Product hierarchy no. *				Part no.	SBU	Type / Description	Customer part no.
SBU	PG	PUG	Туре				
01	002	060	0000000660	0853.0551 0853.0551.G	Circuit protection	OGN cover transparent	n/a
				0853.0575		OGN cover black	n/a

Product Change Notification						OGN Cover isolation material change		
owner	creation date	release date	released by	change order no	rev	page	D40 007 057	
dislercy	2016-08-11	2017-02-01	nowakfr	2011797	Α	1 of 1	D10-007-257

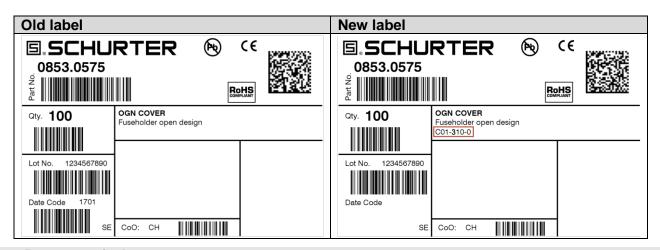
- Change of material
- Modified label

The new material fulfils the glow wire requirements given in IEC60127-6:2014 and are free of halogenated flame retardant and red phosphorus.

Product improvement to fulfil the enhanced glow wire requirements according to the updated standard IEC 60127-6:2014 and the standard IEC 60335-1 for appliances in unattended use.

Form Yes Transparent plastic material changed
